New Jersey Turnpike Authority

Document Change Announcement

DCA2023SD-01

Subject: Revisions to

STANDARD DRAWING
CU-4

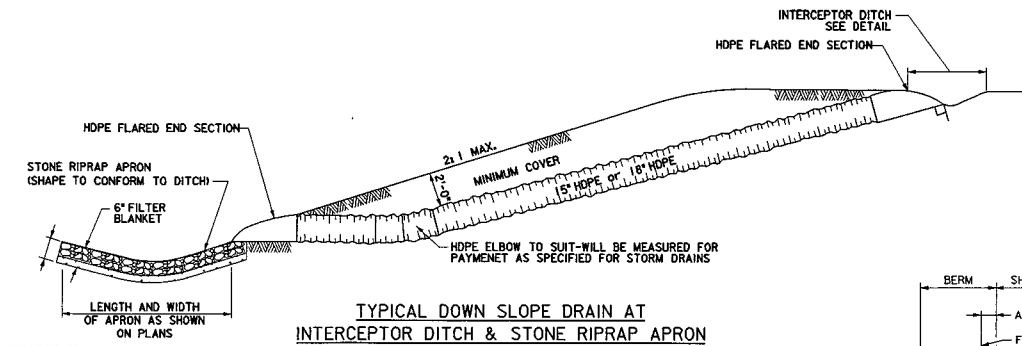
Standard Drawings CU-4 (Lip Curb Inlet Treatment at Bridge Structures) and DR-5 (Concrete Gutter and Slope Drain Details) are updated to replace lip curb inlets with Type D1 drop inlets at slope drains for new construction or complete replacement. New installations or complete replacement of lip curb inlets on Authority roadways have been eliminated. Lip curb inlets details remain in the Standard Drawings as reference for repair of existing installations only.

4. SEE CU-3 AND GR-9 FOR ASPHALT CONCRETE LIP CURB AND BERM SURFACING PLACEMENT.
5. SEE DR-1 FOR TYPE D1 DROP INLET TO BE USED IN LIEU OF DETAILS SHOWN ON THIS DRAWING FOR NEW INSTALLATIONS OR COMPLETE RECONSTRUCTION OF EXISTING LIP CURB INLETS. LIP CURB AND TYPE D1 DROP INLET TO BE PLACED RELATIVE TO THE END OF STRUCTURE CARRYING TURNPIKE OR PARKWAY TRAFFIC AS CALLED FOR ON THE CONTRACT PLANS.

THIS DRAWING MAY ONLY BE USED FOR REPAIR OF EXISTING AUTHORITY LIP CURB INLETS. NEW INSTALLATION OR COMPLETE REPLACEMENT SHALL BE PROHIBITED. SEE NOTE 5.

DR-5

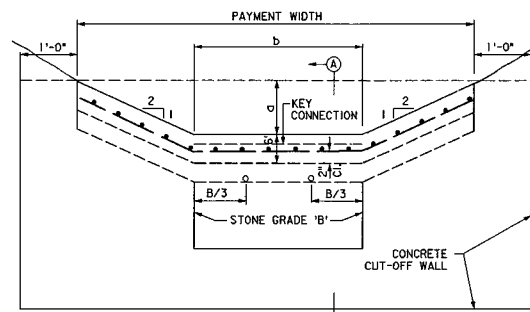
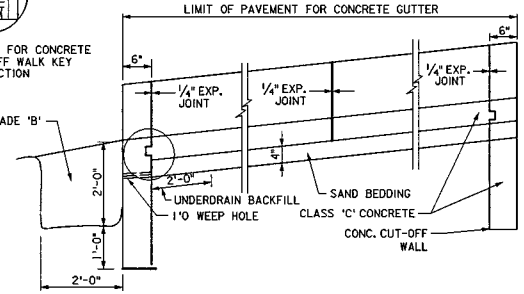
App	No	DATE	REVISION
	1	01/23	REPLACED LIP CURB INLET WITH TYPE D1 DROP INLET
	0	04/09	ORIGINAL DRAWING

ASPHALT CONCRETE LIP CURB INLET
THIS DETAIL FOR REFERENCE ONLY
THIS DETAIL MAY ONLY BE USED FOR REPAIR OF EXISTING AUTHORITY LIP CURB INLETS. NEW INSTALLATION OR COMPLETE REPLACEMENT SHALL BE PROHIBITED.
